# UNITED STATES PATENT AND TRADEMARK OFFICE

10/695,011

<b>Office Action Summary</b>	<b>Application No.</b>		<b>Applicant(s)</b>	
	10/695,011		BAUER, VAUGHN L.	
	<b>Examiner</b>		<b>Art Unit</b>	
	Victor Batson		3671

***Claim Rejections - 35 USC § 112***

FIG. 3

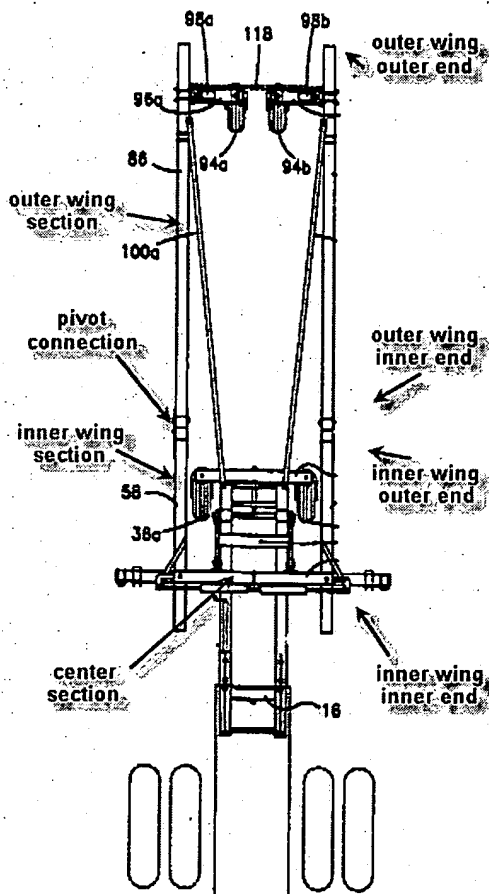
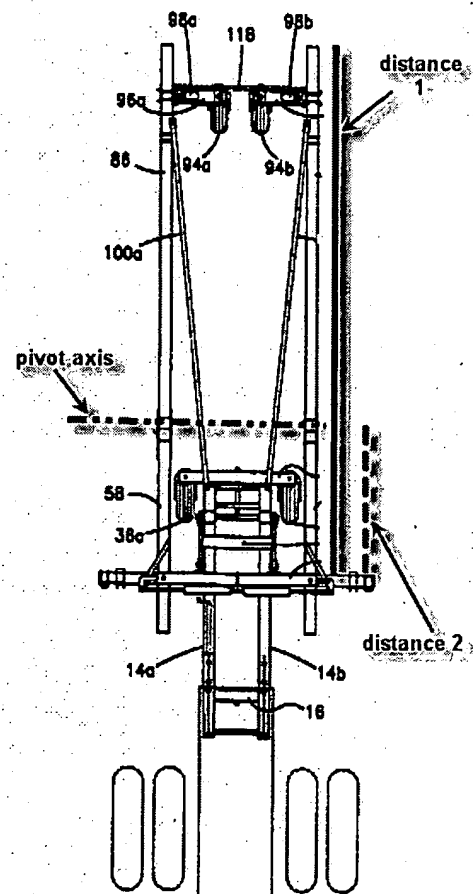
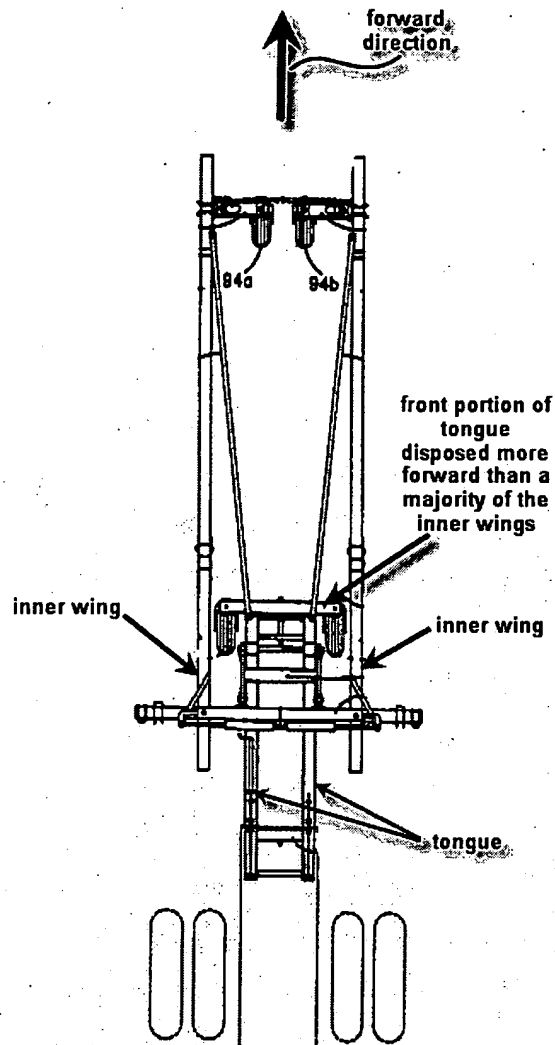
Kirwan discloses a forwardly folding toolbar comprising a tongue, a center section, outer wing sections, inner wing sections, with a distance between the outer end of the outer wing section and the inner end of the inner wing section greater than a distance between the inner end of the outer wing section and the inner end of the inner wing section. Concerning the method claims, given the structure of Kirwan, the claimed

method steps would inherently be performed while the device of Kirwan was assembled and operated. The examiner notes that since part of the tongue of Kirwan is disposed forward of a majority of the inner wings (as set forth in the modified figure below), Kirwan is considered to meet the limitation of the tongue being disposed more forward than the wing sections.

distance 1 &gt; distance 2
